1. SUMMARY associated with D1001346

2. PHOTOS of D1001346

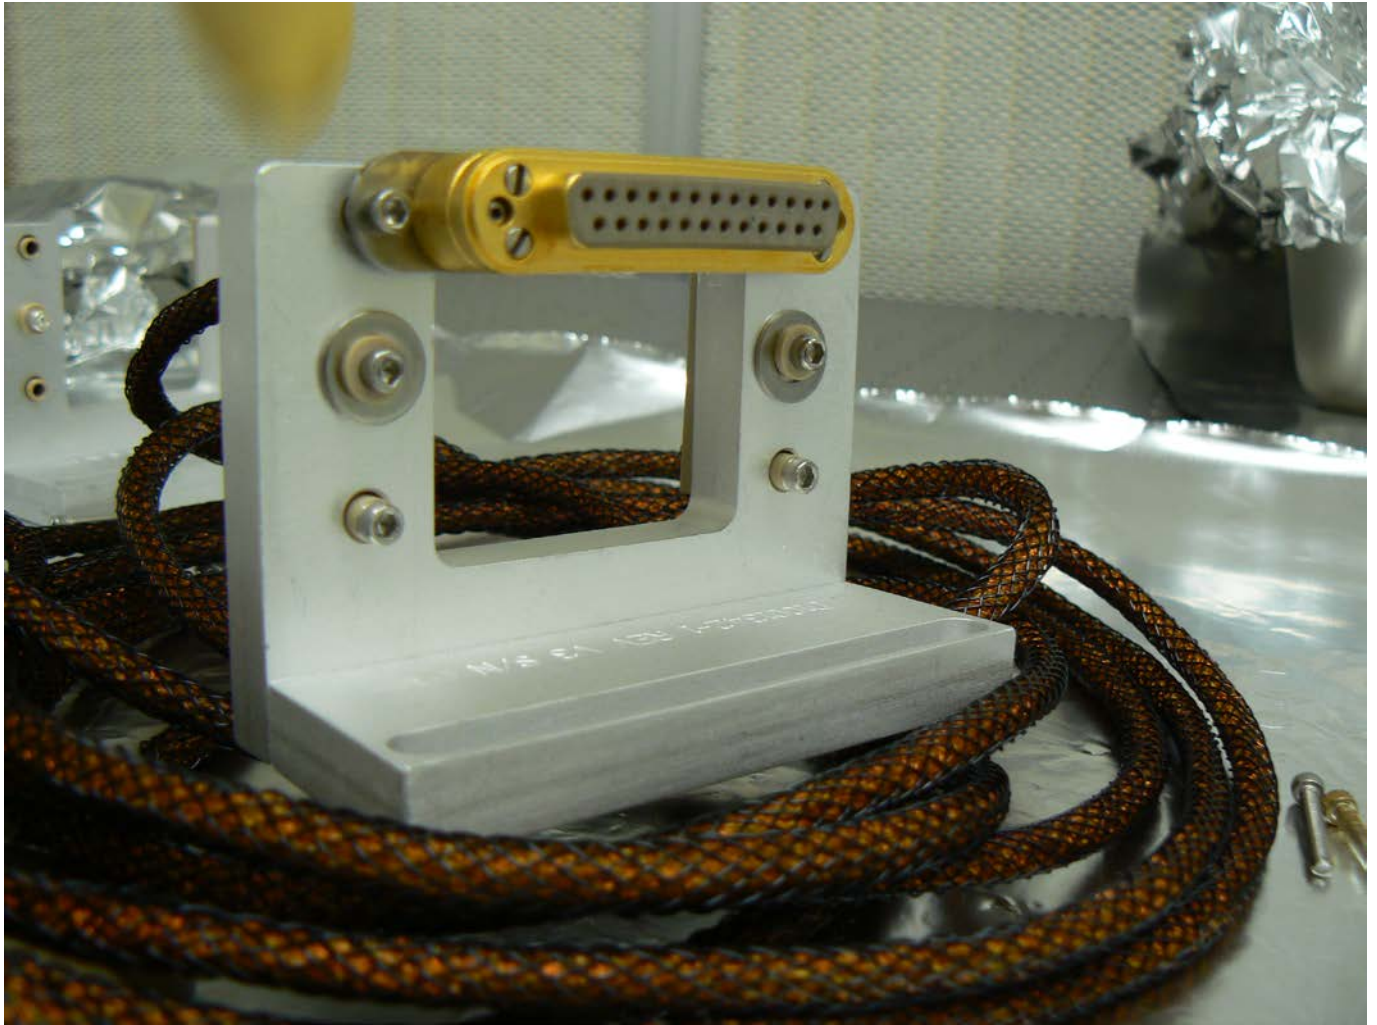
2) While item #1 removes most of the wiggling reported it does not remove all of it. So we recommend a small retrofit, which adds a washer to the assembly, see attached picture. The washer is added during assembly of the L-bracket, so does not become an issue (loose part) when you add the cables. It should be considered as required, the existing assemblies should not be adjusted. A number 10 washer (McMaster Carr, 92141A011) I have ordered several hundred of these, specifically: -

PLEASE NOTE PHOTO SHOWS WASHER RETROFIT WITH WRONGLY SIZED WASHER, SHOULD BE No 10 WASHER AS PER SECTION 1 OF THIS DOCUMENT

18-8 SS General Purpose Flat Washer NO. 10 Screw Size, 7/16" OD, .02"-.04" from McMaster Carr order number 92141A011.
